**Road Safety Audit**  
**Stage 1**  
**for**  
**ACCESS TO PROPOSED RESIDENTIAL DEVELOPMENT**  
**AT**  
**ST PATRICK'S COTTAGES, RATHFARNHAM, DUBLIN 16**

**Reference:** RSM/MOB/180722/RATHFARNHAM RSA1 UPDATE

<b>Client</b>	Magahy Broderick Associates
<b>Project Title</b>	Access to Residential Development, Rathfarnham, Dublin 16
<b>Document Title</b>	Stage 1 Road Safety Audit Update
<b>Document Ref.</b>	RSM/MOB/180722/RATHFARNHAM RSA1 UPDATE
<b>Status</b>	FINAL

**Figure 8: Vehicles Parking on Narrow footways on northern Site Boundary**

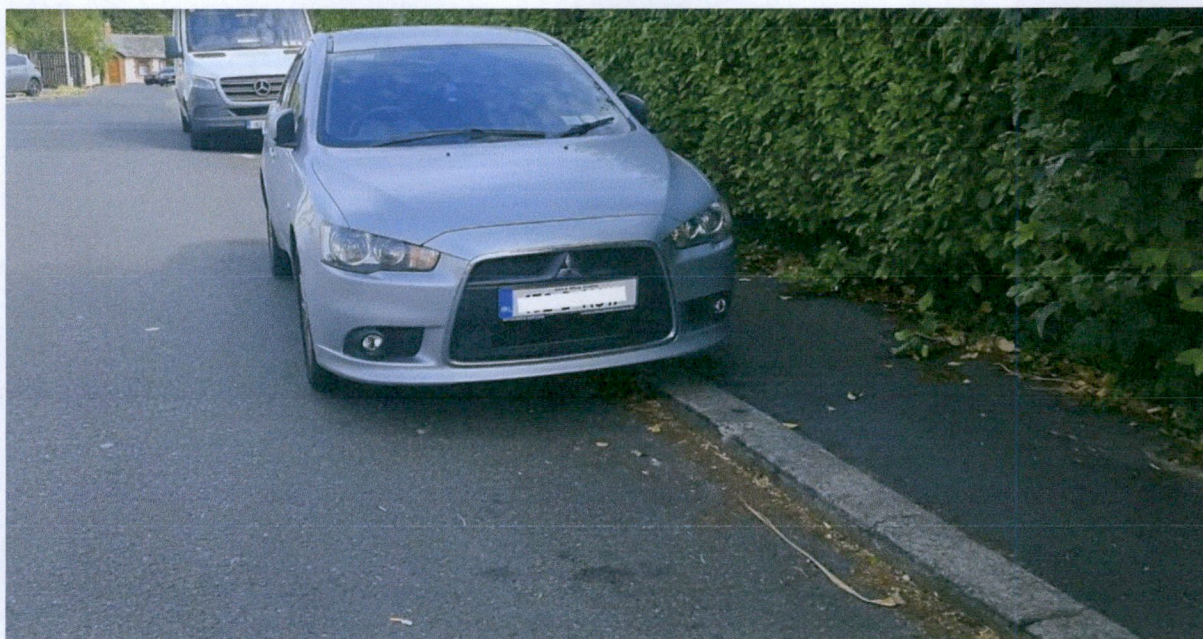
The design proposals include provision for one off street parking space per dwelling. There was no information provided on anticipated parking demands and parking accumulation for the site, however significant on street parking was noted on both sides of the carriageway at present, some of it partially blocking footways and pedestrian movements, as shown in photos in figures 3-8. The continuation of on street parking at this location would restrict visibility to and from vehicles wishing to turn out of the 4 proposed driveway access points, and is also likely to restrict safe unobstructed two-way movement on the link, and obstruct the swept paths and turning movements of vehicles wishing to turn, hence the Design team have confirmed that parking along the site frontage will be discouraged through provision of suitable parking restrictions in consultation with the Local Authority.

1. Suitable forward visibility and Stopping Sight Distance (SSD) should be provided towards the rear of any potential queues arising for right turners into each of the proposed site access points.
2. Visibility throughout and on approaches to the site should be clear and unobstructed at all times in accordance with approaching traffic speeds.
3. The cumulative parking demand should be assessed to demonstrate that the proposed number of parking spaces will cater for all anticipated demands, with provision for parking restrictions where necessary on approaches to each access point to ensure vehicles do not park on-street where they may restrict visibility, turning movements or safe two-way movements for other vehicles, as well as potentially restrict the movement of pedestrians.
